Modification Recommended Service Note

N8954A - Autoranging System DC Power Supply, 500V, 90A, 15000W, 400 VAC

Serial Numbers: DE14290000 - DE15369999 without manufacturing ID Version "B"

The Problem:

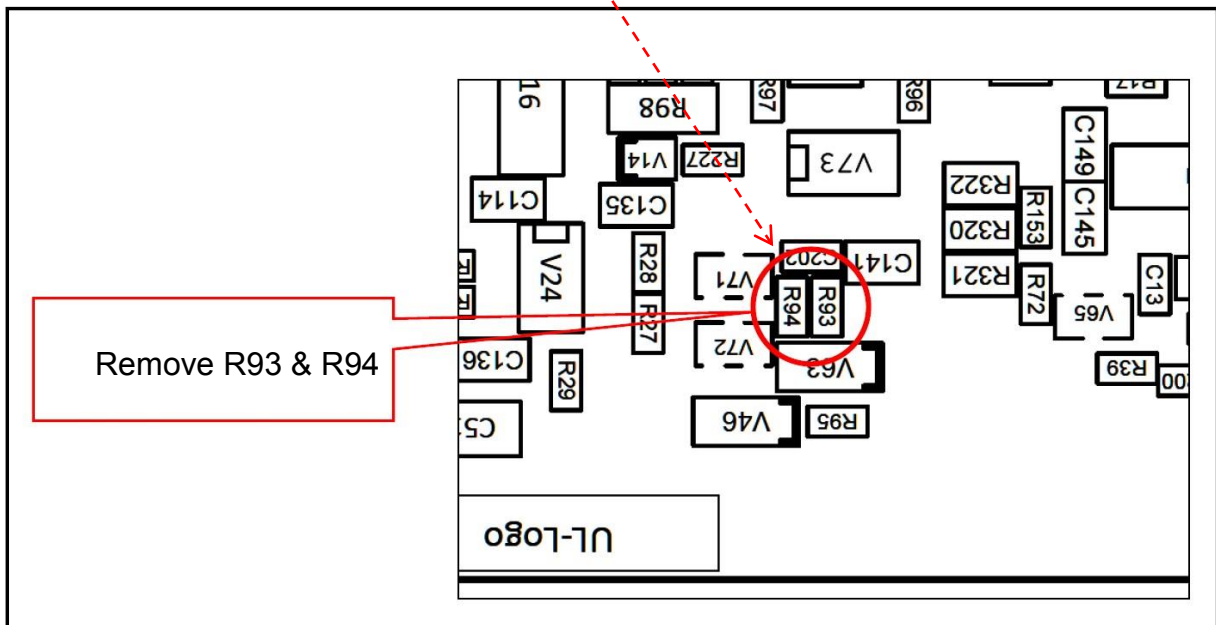
- 1) Remove acMains cable from power source.
- 2) Wait 5 minutes
- 3) Remove top cover from instrument.
- 4) In the 5kW units (viewed from the front of the unit), a small SMT assembly located at the right-rear of instrument will be readily visible (see below):

5) SMT resistors R93/94 are located in red circle shown below:

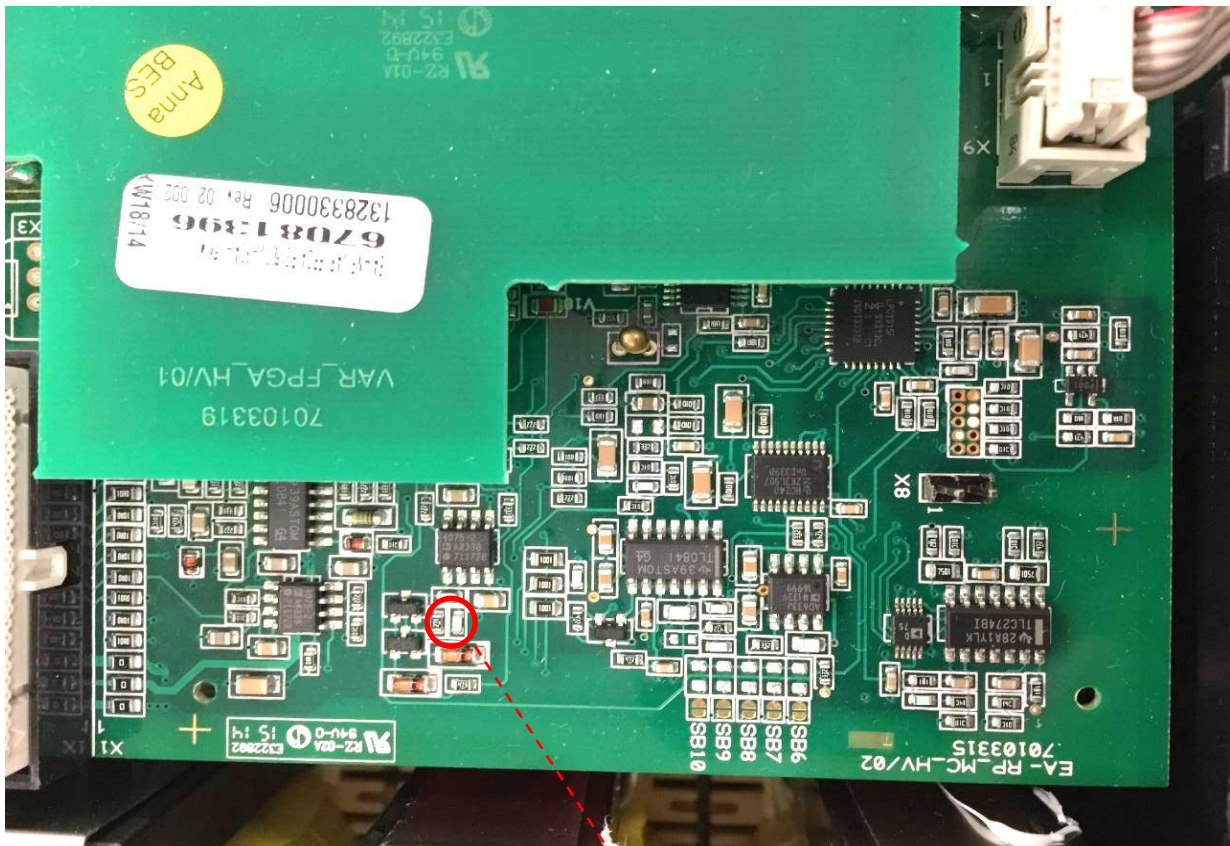
Removal of two (2) surface mount resistors, R93 and R94, will correct this problem:

Suffix “B” added

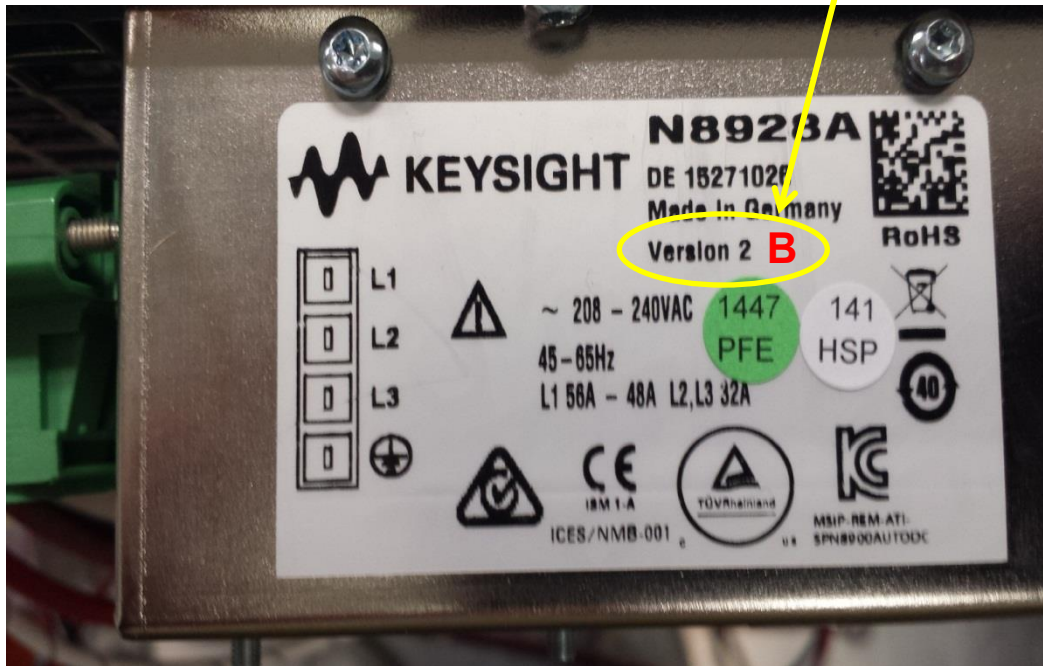
7) On the acMains label, on the rear of the instrument; use an indelible marker, to add the suffix letter “B” after the Version ID. This will assist in the tracking of modified instruments.
